# Access Compliance Report

## Public Rights-of-Way

| Intersection ID: 53391                  | Main Street: EBBETS_RD | Cross Street: VAWTER_DR                 | Location: SW           |
| ADA ID: E0D029B6CECF                    | Ramp Type: Perp        | Initial Pass/Fail: Fail                 | Overall Compliance: No |

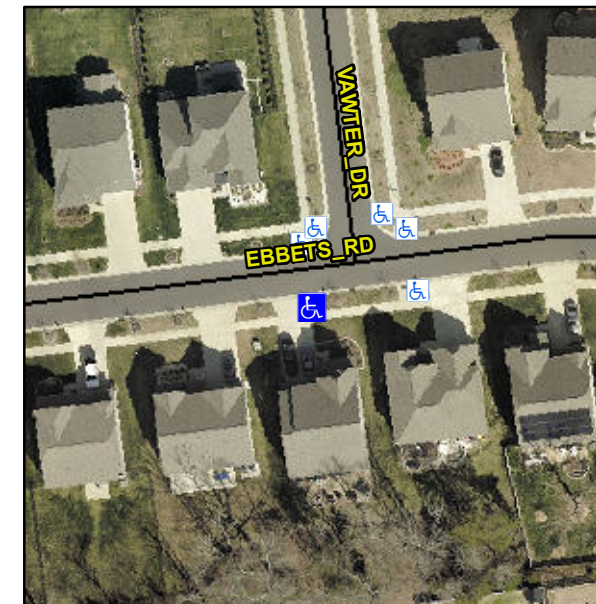
**R304.5.3**

| Compliance | Description           | Data | Compliance | Description                 | Data |
|------------|-----------------------|------|------------|-----------------------------|------|
| Yes        | Ramp Width (in)       | 48.0 | No         | Ramp XSlope (%)             | 6.8  |

**Remove & Replace Entire Ramp.**
